Access Compliance Report

Public Rights-of-Way

Intersection ID: 45731	Main Street: REDWOOD_VALLEY_LN	Cross Street: PROVENCE_LN	Location: SE
ADA ID: 574168BA527A	Ramp Type: PerpDiag	Initial Pass/Fail: Fail	Overall Compliance: No
Severity Score: 12.5			
Codes/Mitigation Info/Possible Solution		Field Measurements/Component Compliance

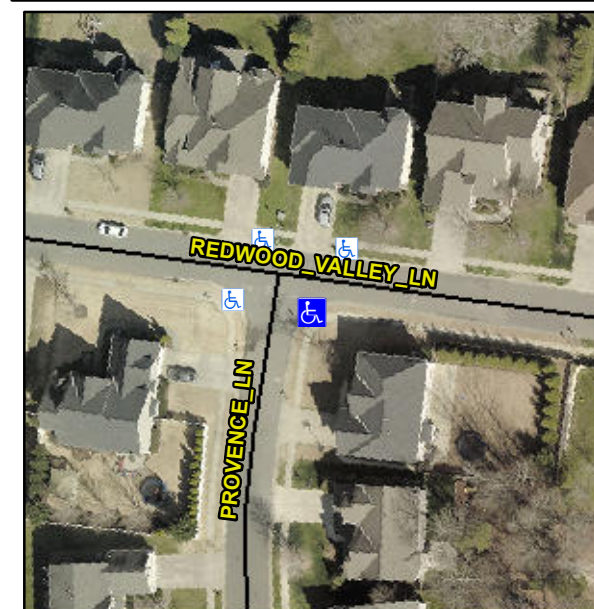
Remove & Replace Curb Ramp With Two New Directional Ramps or Equivalent.

Not Found, R304.5.3
